STEBG-AAAB-4D-3510-03

SUBJECT: Report of Test, USATECOM Project No. 4D-3510-03, Check

Test of Helicopter Performance and Load Computers and

Aerology Kit.

Figure 1. The aerology kit consists of a plastic-carrying case (1), a sensitive altimeter (2), a wind-velocity gauge (3), and a sling psychrometer (4)

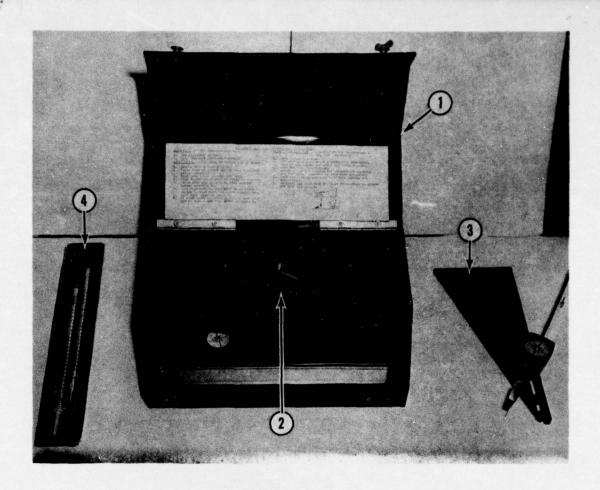
- (1) Suitability of Modifications. Modifications incorporated were found to be suitable with the exception of the following:
- (a) The plastic material, which was substituted for the metal of the prototype kit carrying case, was unsatisfactory. Of three

kits shipped by mail, two suffered damage. In addition, the fasteners on the plastic case were difficult to fasten.

- (b) Two of the four altimeters (one spare) supplied with the three kits were unreliable.
- (c) The windmeter lacked the ruggedness to withstand normal field usage.
- (2) Accuracy of Data. Data obtained from use of the sling psychrometer and windmeter were consistent with that of weather station observation, except for wind velocity determinations in gusty wind conditions.

Deficiency	Corrective Action	Remarks
a) The carrying case for the aerology kit was too fragile.	Construct the carrying case of a light weight, durable and unbreakable material.	Light weight metal, Fiberglas, or material with similar character- istics may be suitable.
b) The Dzus fasteners on the carrying case were difficult to close.	Use suitable fasteners.	
c) The construction of the windmeter lacked ruggedness to with- stand normal field use.	Strengthen the con- struction of the wind- meter.	The weight attached to the vane needs a more secure method of attachment. The wind vane separated from the rest of the unit.

a) There were no reference marks on the compass case to facilitate reading wind direction and orientation 90 degrees to wind direction.

b) There were no reference marks to indicate the proper location of the receptacles in which the stop pins of the wind indicator should be positioned.

Provide suitable reference marks at 0 and 270 degrees on the compass case.

Provide suitable reference marks when the indicator is calibrated for accuracy.
